# FINAL PLAT

## PINE MEADOW SECOND ADDITION

RE: SUB 2001-98 -- One-Step Final of Pine Meadow Second Addition

**CASE NUMBER:** SUB 2001-98 -- PINE MEADOW SECOND ADDITION

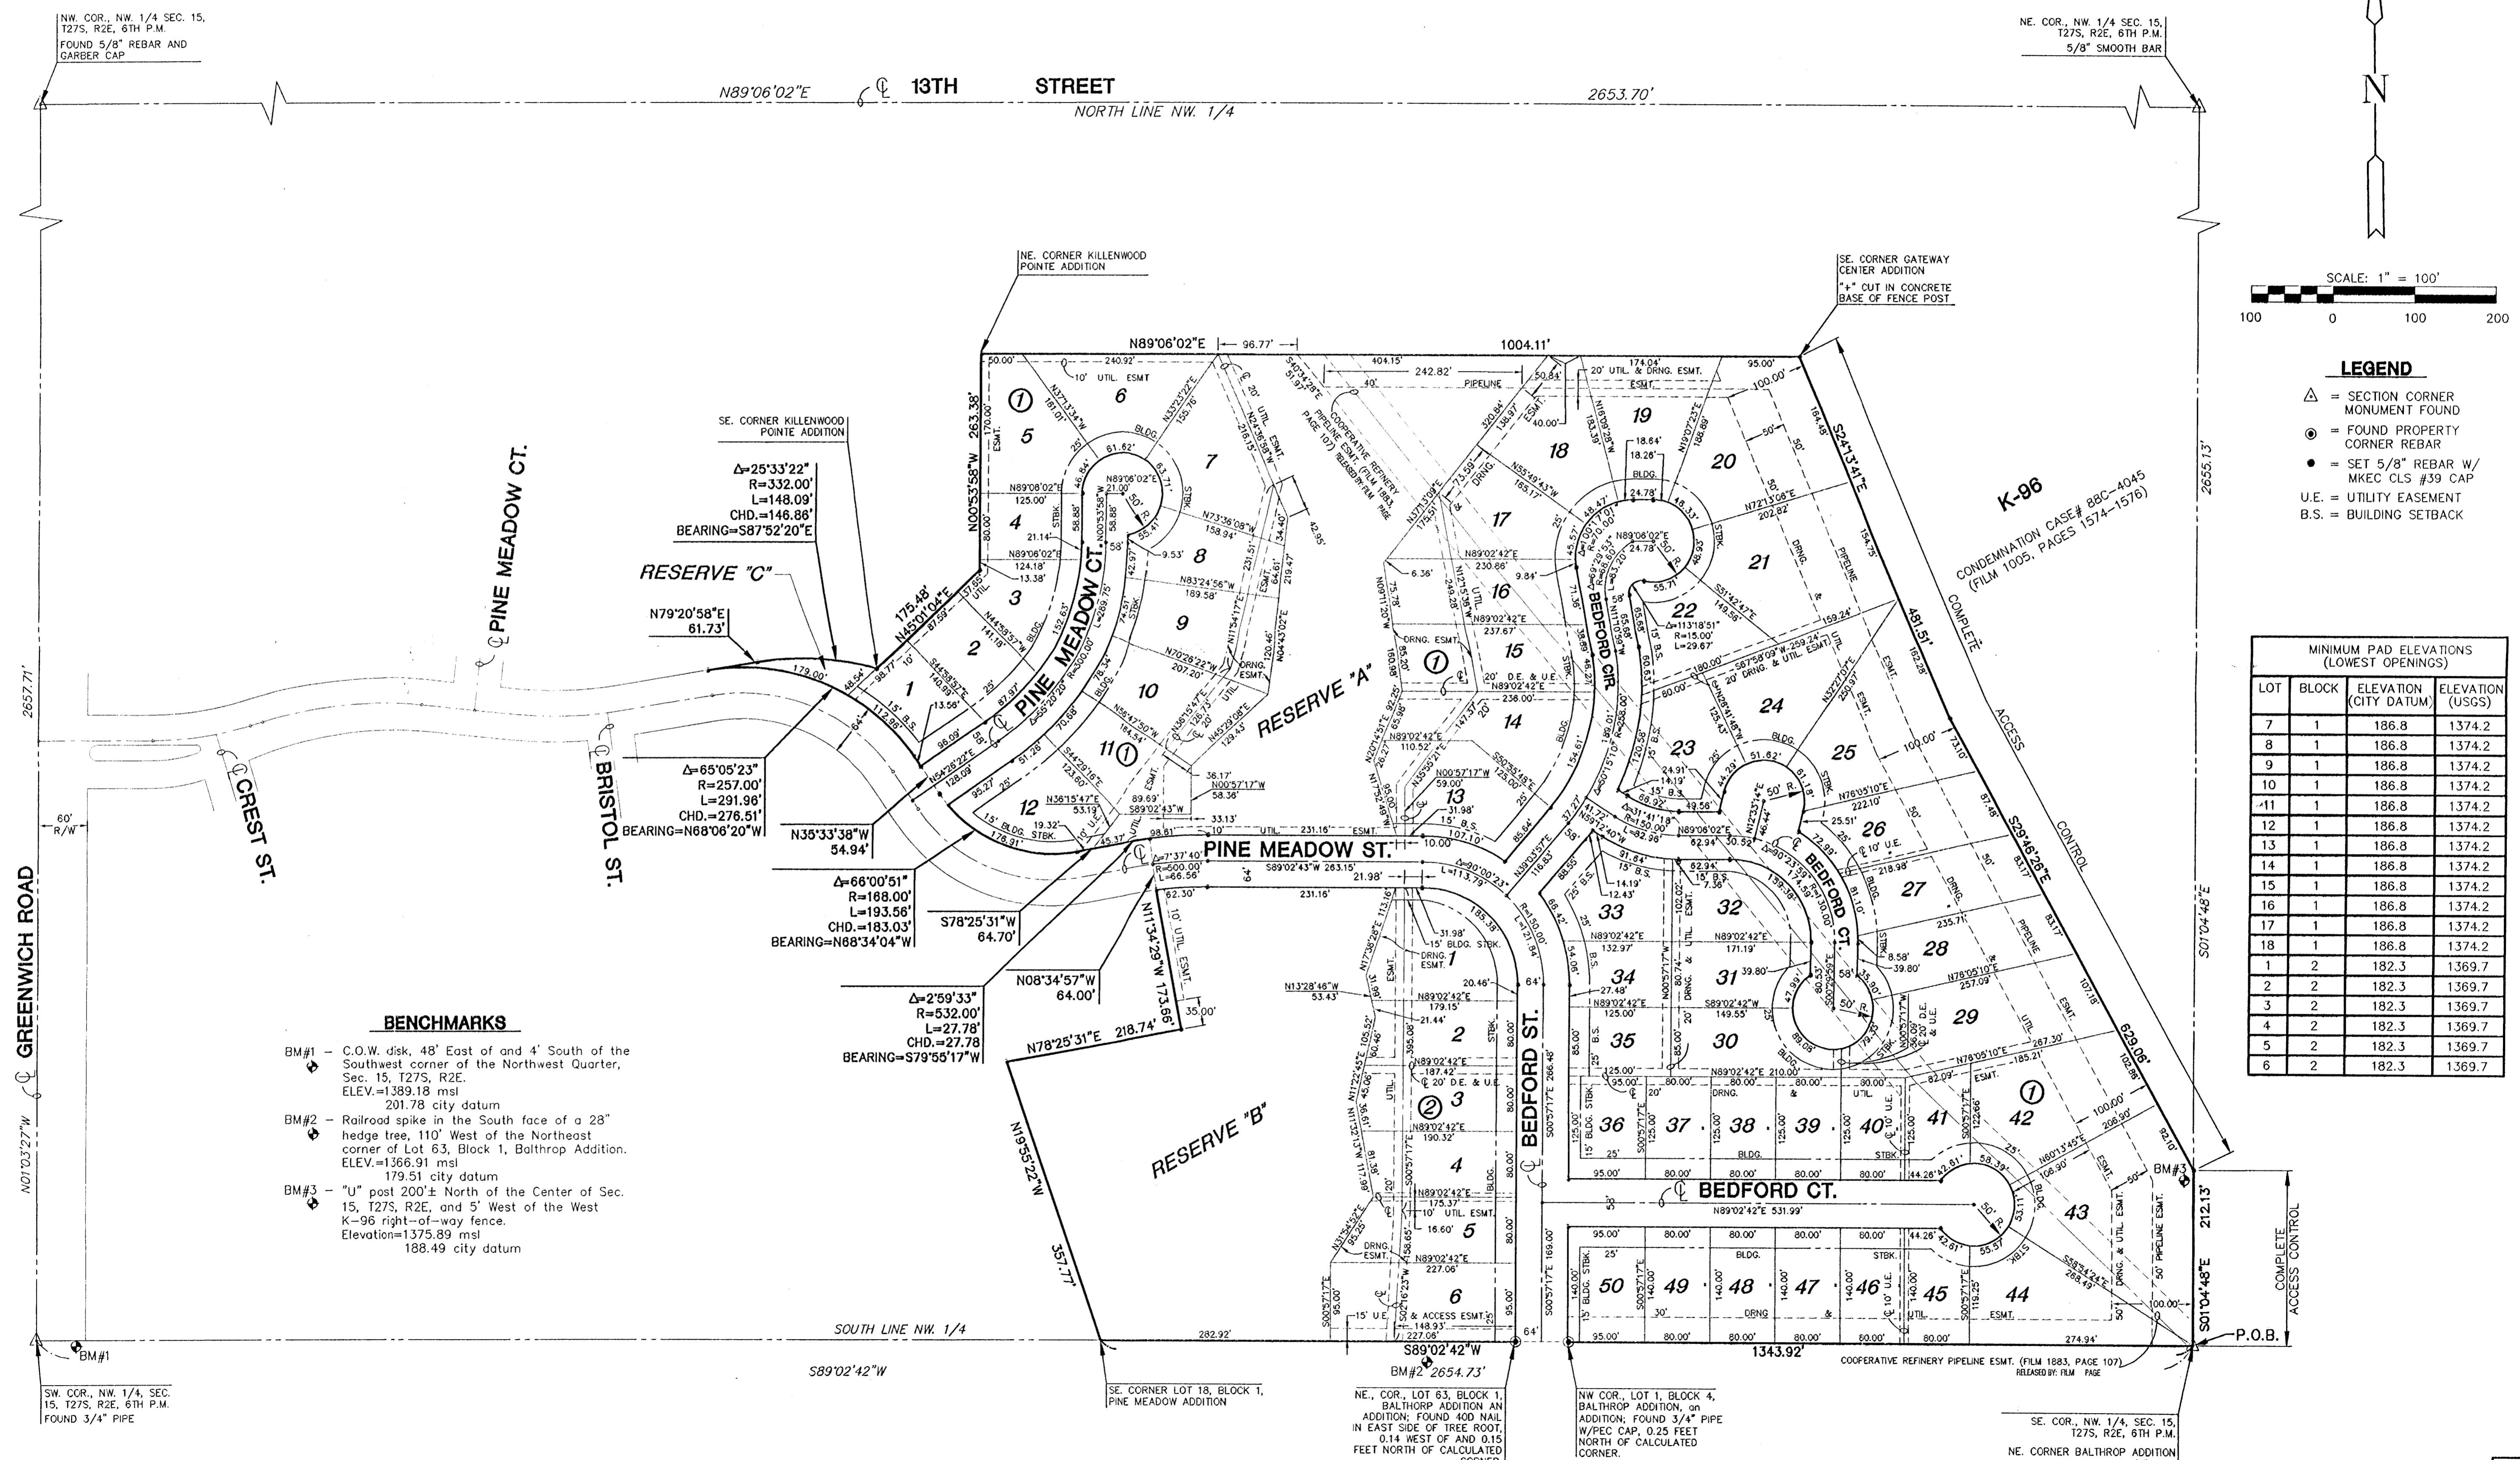
- G. The applicant shall submit a copy of the instrument which establishes the pipeline easements on the property, which verifies that the easements shown are sufficient and that utilities may be located adjacent to and within the easements.

- H. The applicant's agent shall determine any setback requirements for the pipelines by researching the text of the pipeline agreements. If a setback from the pipeline easements is provided for in the pipeline easement agreements, it shall be indicated on the face of the plat.

- I. The recording information for all pipeline easements shall be indicated on the face of the plat.
- J. The Subdivision regulations discourage the inclusion of pipeline easements within the perimeter of residential lots. It is recommended that the pipeline crossing Block 1 be included within a Reserve. In the alternative, a restrictive covenant shall be provided indicating the pipeline easement within the pertinent lots.

- M. The blocks need to be renumbered as the perimeter of the blocks should be bounded by streets.
- N. Approval of this plat will require a waiver of the lot depth to width ratio of the Subdivision Regulations for Lots 9, 13-16, Block 1. The Subdivision Regulations state that the maximum depth of all residential lots shall not exceed 2.5 times the width. **A modification has been approved.**

- O. The **County Fire Department/GIS** needs to comment on the plat's street names. **GIS has requested that Pine Meadow and Pine Meadow Ct be renamed Killenwood and Killenwood Ct.**

- Z. The representatives from the utility companies should be prepared to comment on the need for any additional utility easements to be platted on this property. **KGE and Southwestern Bell have requested additional easements.**
